**Title: Separate Physical Layer Preamble and PLCP Headers**

**Date: July 7, 1995**

This submission reviews the concept of having a common PLCP PHY header for the 802.11 PHY layers. This paper focuses on the PLCP header from a DS PHY prospective, comparing the DS PHY fields in the header against the FH PHY and IR PHY PLCP header fields as described in the P802.11D1.1 working draft. The intention of this submission is to present some observations between the respective PHY PLCP headers and possible practical implications for having a common header, in products which will support the standard.

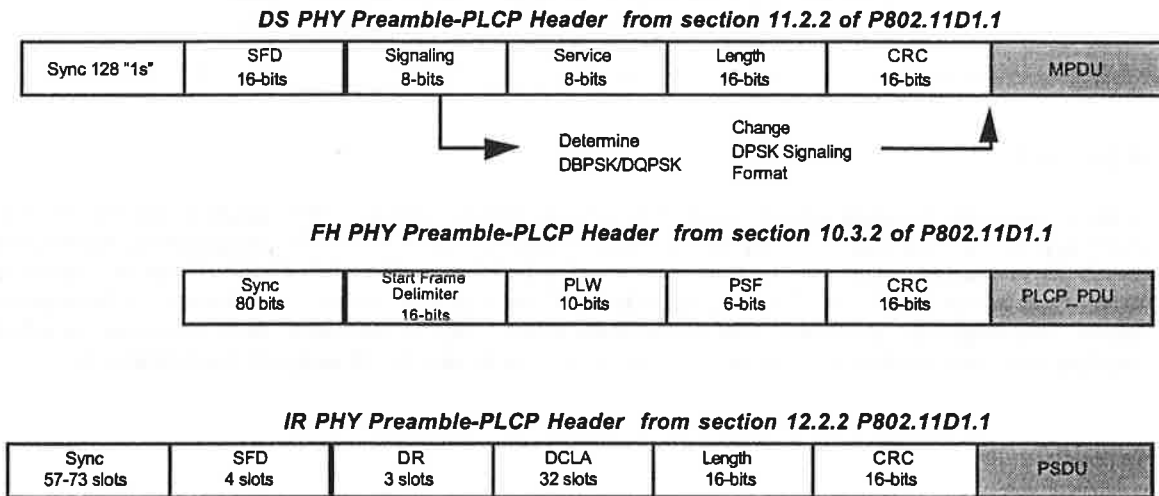
The bottom line is that the modulations of the (3) PHYs are distinctly different and any attempt to achieve a common PLCP will result into inefficiencies for ALL PHYs. The diagram below illustrates from a top level these differences. These differences apply to the actual fields as well as the number of bits required for each of the PHYs. Any attempt for commonality will introduce less than optimum PHYs.

The assumption is that products supporting the standard will be introduced for one PHY or the other. It is also clear that respective specific 802.11 PHY types will not communicate with each other because of the fundamental differences between the spreading architectures and modulation signaling types. If we consider the scenario of having one common header, WLAN products designed to the standard would be burdened with the penalty of processing additional PLCP header field bits, which are PHY specific. Lastly, if we consider the semiconductor industry, semiconductor manufacturers are likely to introduce products which supports the PHYs individually, and products that support the MAC protocol. The likelihood of combining all of the MAC and PHY functions universally, into a highly integrated RF-to-bits silicon solution is small, because of process technology limitations, cost and system testing issues. Therefore we recommend that the PLCP headers remain separate as currently proposed, in P802.11D1.1 to minimize overhead burdening of PHY products which will support the standard.
